# Winterbourne Wind Farm

Amendment Report

3 October 2024

0526676

Coordinate System:  
 GDA 1994 MGA Zone 56  
 Date: 06/09/2024  
 Created By: VN  
 Drawing Size: A3  
 0 500 1,000 1,500m

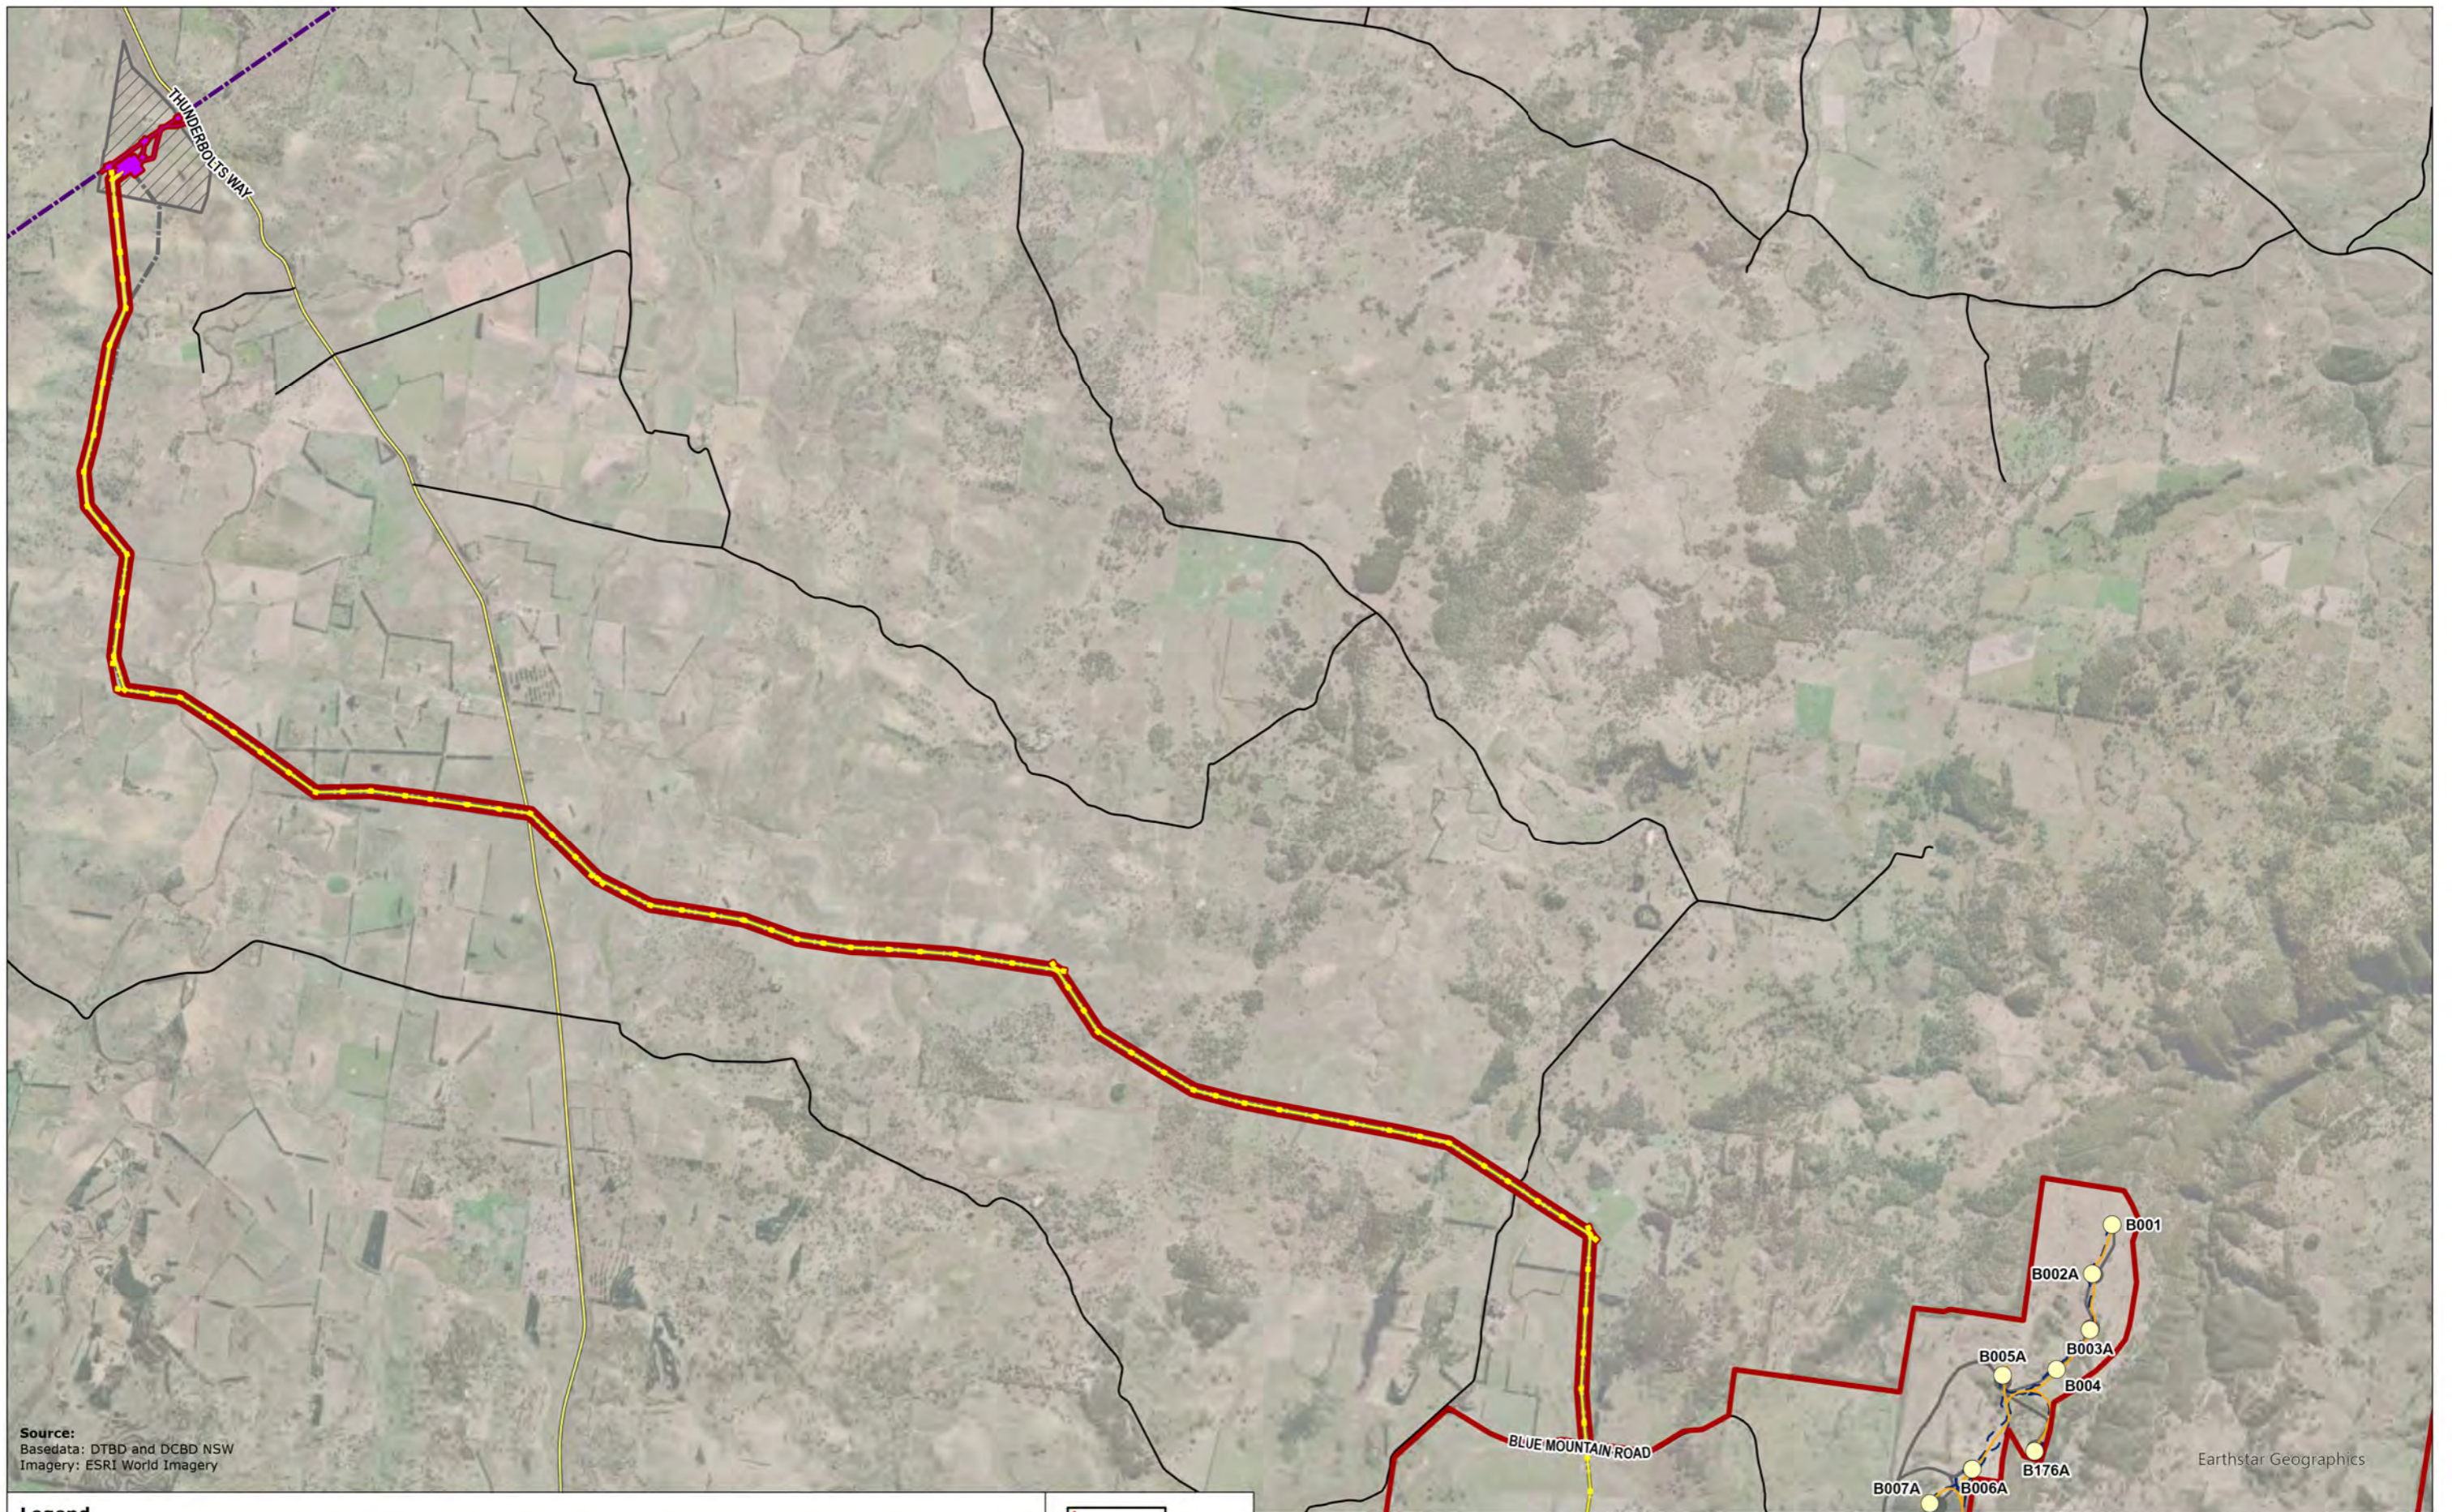
Amendments include relocation and/or removal of elements of the Project, as well as optimisation of other project infrastructure areas. The amended Project Area is shown in **Figure 3-1**. The amended Project Layout is shown in **Figure 3-2**.

The Applicant has refined the Project design in response to agency advice and public submissions received, as well as constructability considerations. These design refinements include:

- Refinement of two (2) WTGs to provide at least 600 m buffer from the WTG to the National Park boundary;
- Refinement (<100m movement) of three (3) WTGs and relocation (>100m movement) of two (2) WTGs to address concerns raised by NSW Telco Authority relating to potential impacts to point-to-point telecommunication links;

- Revised site access along public roads to match revised internal access track layout;
- Realignment of underground electrical reticulation and addition of four sections of overhead 33 kV electrical transmission line to reduce biodiversity impact;

- Relocation of north substation, maintenance building, construction compound, BESS and laydown area approximately 1.8 km west to improve constructability, reduce biodiversity impact and provide a greater buffer between infrastructure and public roads;
